No: 24-101

DAUPHIN COUNTY SUBDIVISION/LAND DEVELOPMENT REVIEW REPORT

FINAL MINOR SUBDIVISION PLAN **FOR** HALIFAX TOWNSHIP - FORT HALIFAX

FINAL MINOR SUBDIVISION PLAN

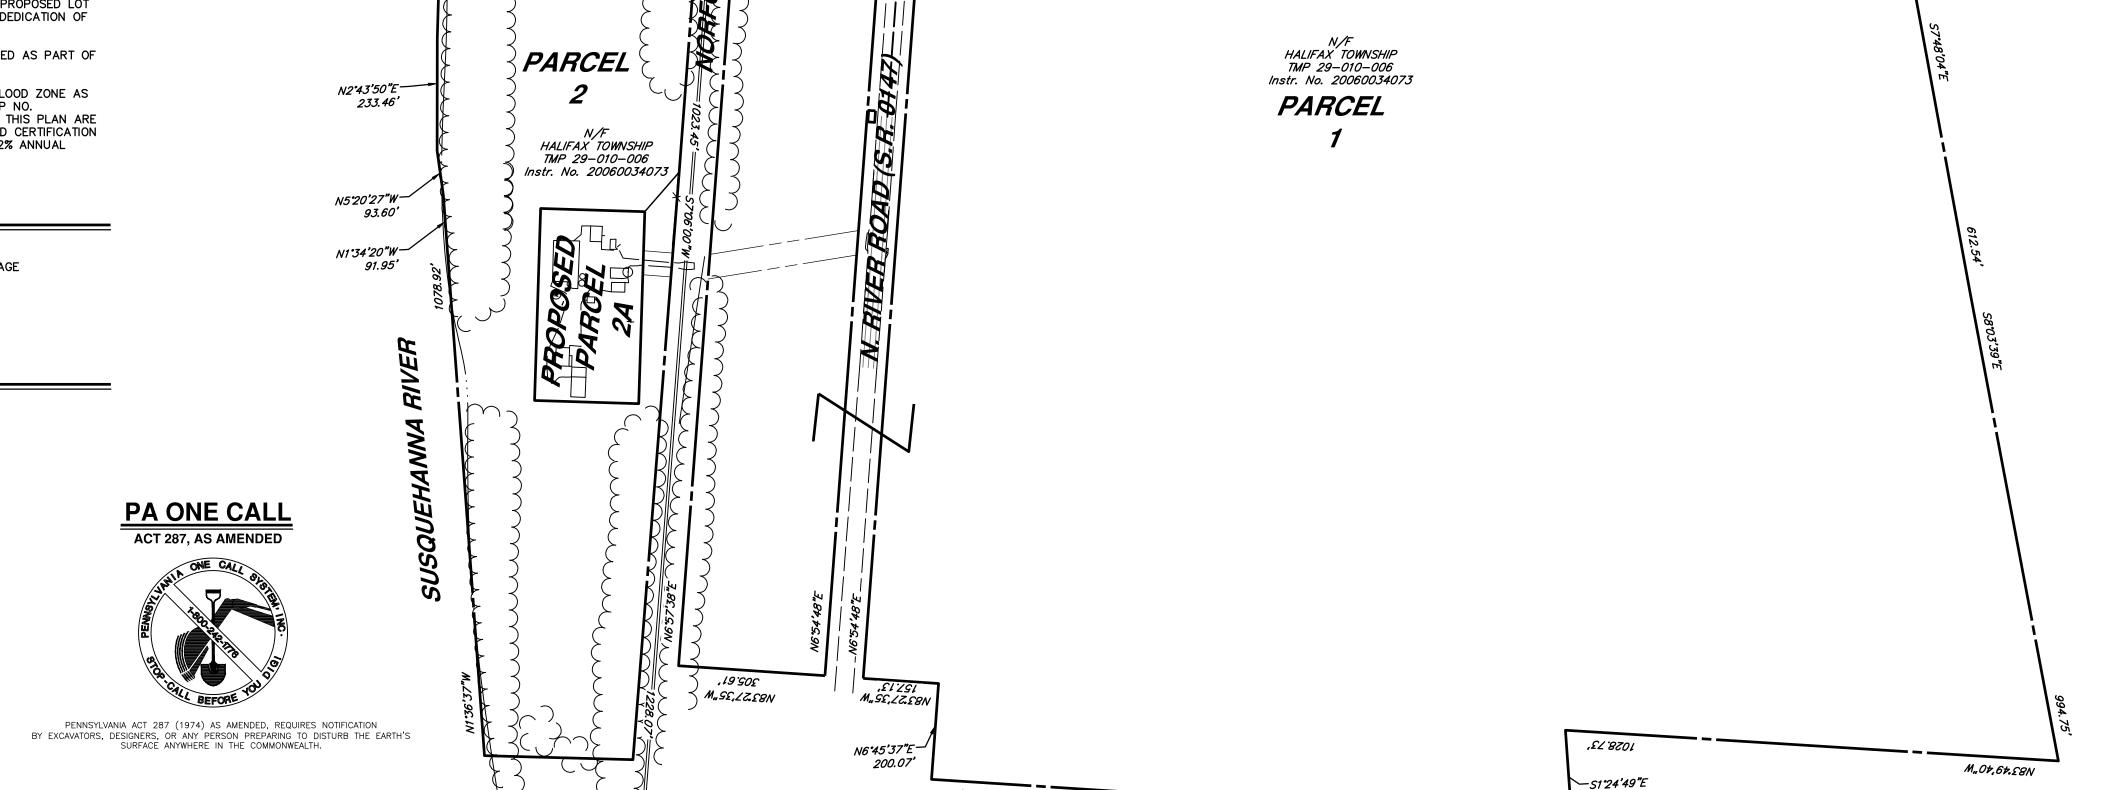
- 2. The names of owners of all abutting land are required to be displayed. (SALDO Section 405.1.a.vi per Section 407.1.a)
- 3. Any existing easements or rights-of-way, specifically utility, is required to be displayed. (SALDO Section 405.1.a.ix per Section 407.1.a)

- 4. The primary control point is required to be displayed on the plan in accordance with SALDO Section 407.1.a.i
- 5. A final Erosion and Sedimentation Control Plan is required in accordance with SALDO Section 407.1.a.ix. The plan displays the applicant's intent to request a modification of this requirement.

- 6. A final stormwater management plan is required in accordance with in accordance with SALDO Section 407.1.a.xii(10). The reviewer notes the plan does not propose any earth moving activity.

- 7. The location of the on-lot septic system should be displayed on the plan for reference.
- 8. Ensure all signatures, certifications, and notarizations are in place prior to final approval.

- 9. Ensure Maximum lot coverage is in accordance with SALDO Section 505.3.a. The plan displays the applicant's intent to request a modification of this requirement.

- 10. Monuments and markers are required to be set in accordance with *Section 602* of the Halifax Township Subdivision Ordinance.
